# Service Bulletin SB-0049

**Subject:** Right Bus-Bar Interference

**Labor:** 1 hour inspection, 4 hours if work is needed **Effectivity:** K003– K041

**Affected Model(s):** E1000 GX **Due:** Next annual inspection.

Figure 1: Right Circuit Breaker Panel - Before Modification

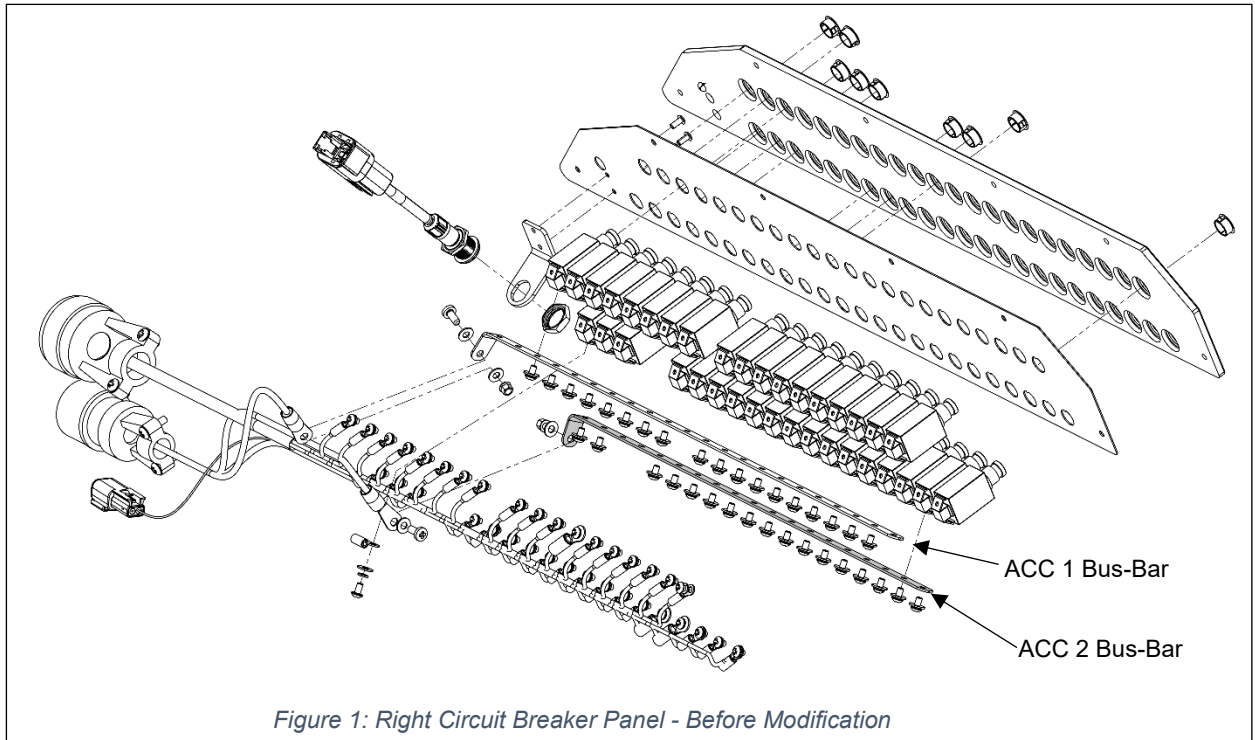
On affected aircraft, it has been found that ACC 1 and ACC 2 in the right-hand circuit breaker panel may have fitment issues as designed.

5. Gain access to the right circuit breaker panel ACC 2 bus-bar (refer to Figure 1).
  - a. Remove right hand circuit breaker cover.

This Service Bulletin contains instructions to rework the ACC 2 bus-bar, inspect ACC 1 bus-bar, and rework if needed to prevent contact.

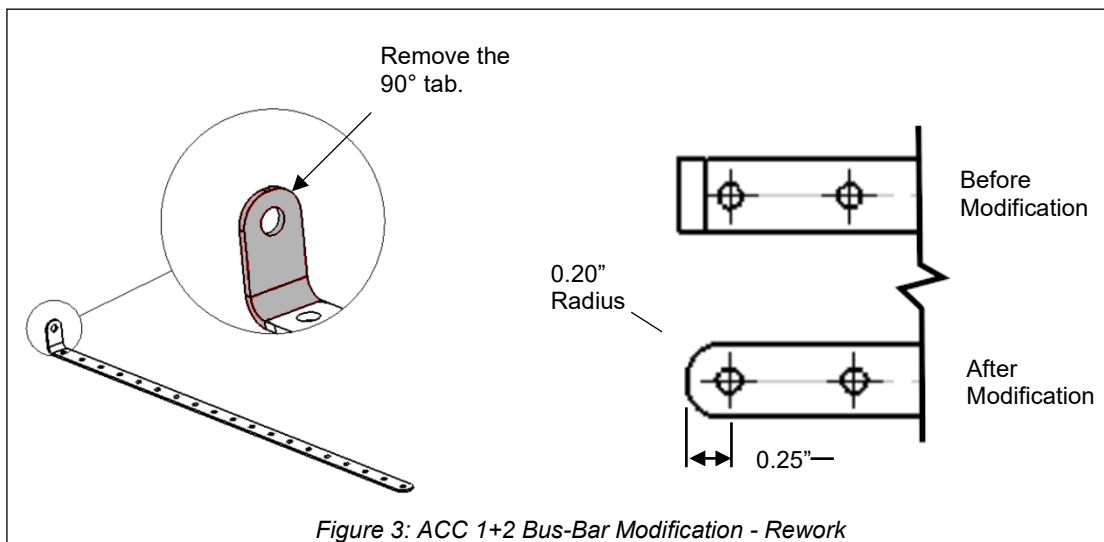
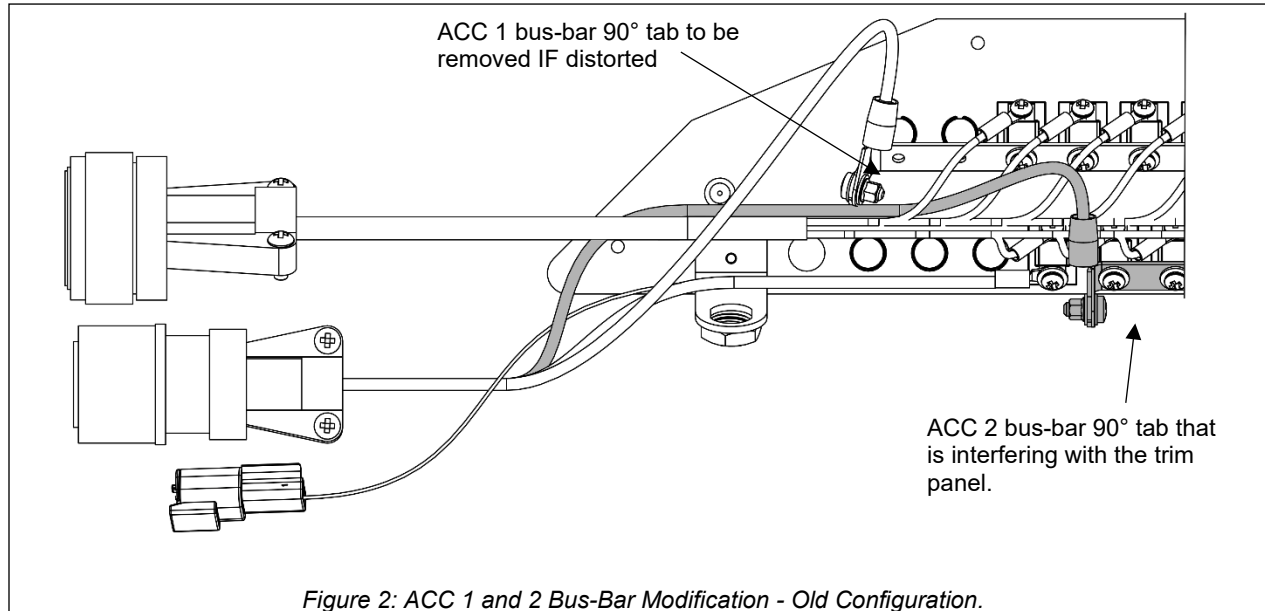
10. Remove the ACC 2 bus-bar from the right circuit breaker panel.
11. Modify the ACC 2 bus-bar as follows (refer to Figure 2 and Figure 3):
  - a. Remove the 90° tab from the ACC 2 bus-bar.

- b. Put a 0.20" radius on the modified end of the bus-bar.
  - c. Apply solder to the reworked end of the bus-bar for corrosion protection.
12. Put the ACC 2 bus-bar in position on the right circuit breaker panel.

- a. Remove the 90° tab from the ACC 1 bus-bar.
  - b. Put a 0.20" radius on the modified end of the bus-bar.
  - c. Apply solder to the reworked end of the bus-bar for corrosion protection.

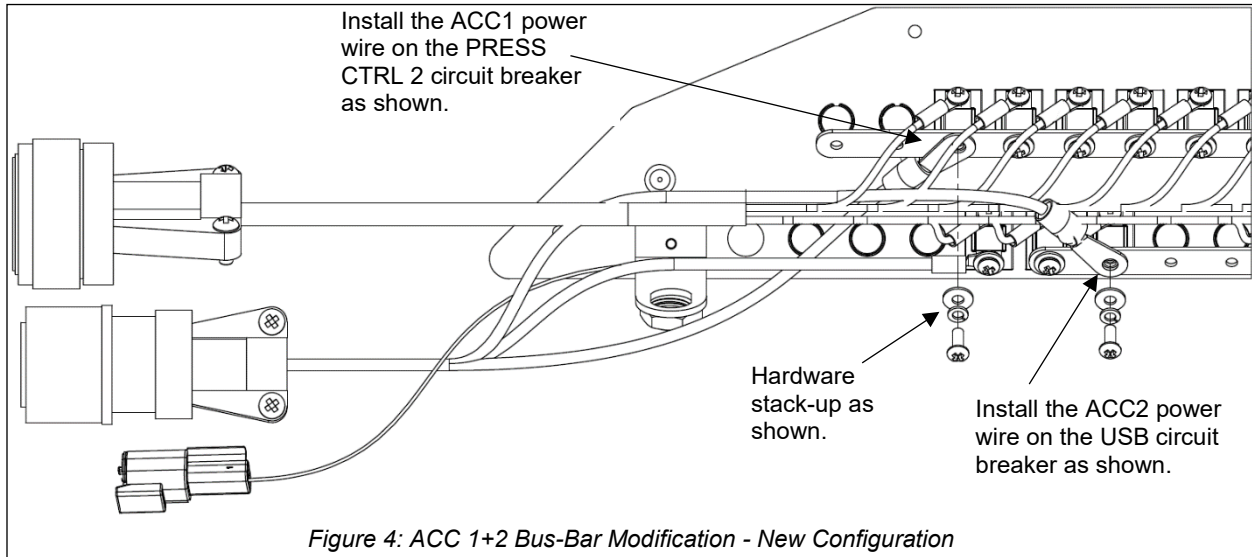
13. Install all screws and washers that attach the ACC 2 bus-bar to the circuit breakers, except for the USB circuit breaker.
14. Attach the K2460110C-8 wire to the USB circuit breaker using the MS51957-28 screw, NAS1149FN632P washer, and lock washer retained from the USB circuit breaker (refer to Figure 4).

23. Attach the K2460109C-8 wire to the PRESS CTRL 2 circuit breaker using the MS51957-28 screw, NAS1149FN632P washer, and lock washer retained from the USB circuit breaker (refer to Figure 4).
